7272 Wisconsin Avenue: Sketch Plan No. 320160040

Description

SECTION 1: RECOMMENDATION AND CONDITIONS

Figure 5 – Sketch Plan

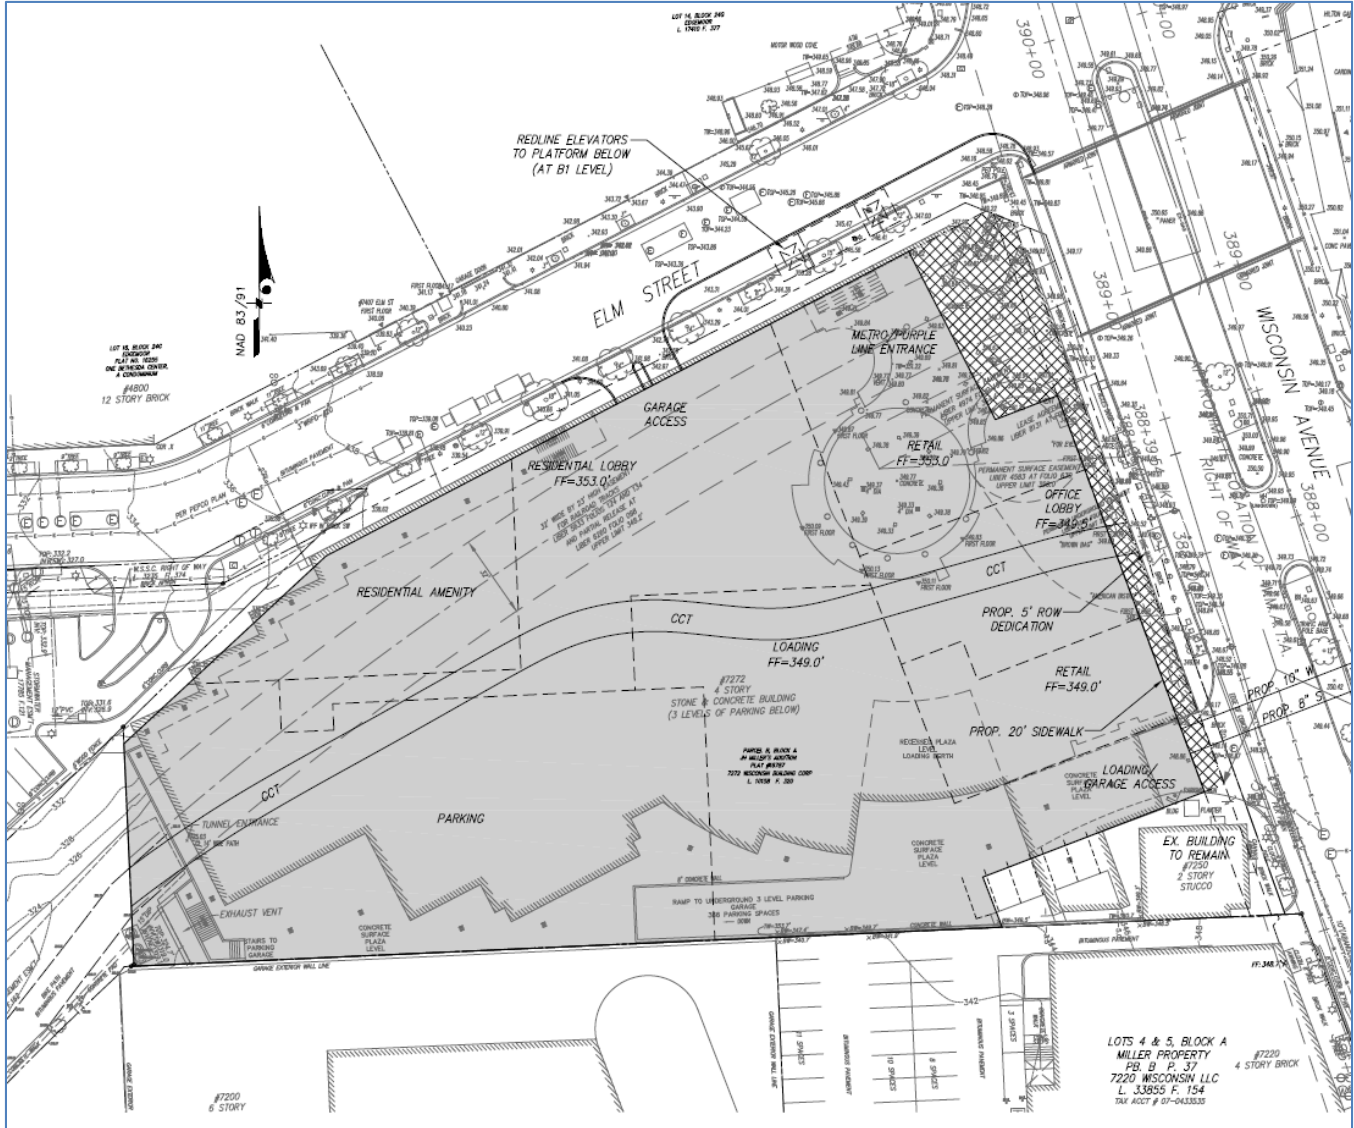
1. Straighten the trail alignment through the building so that the prevailing alignment is more “straight” than curvilinear;
2. Coordinate a smooth transition to the trail at the western property line;
3. Show the future eastern limits of the tunnel under Wisconsin (to the eastern ROW line on MD 355);
4. Consider an art component in tunnel; and
5. Work to minimize vertical change for the Capital Crescent Trail.
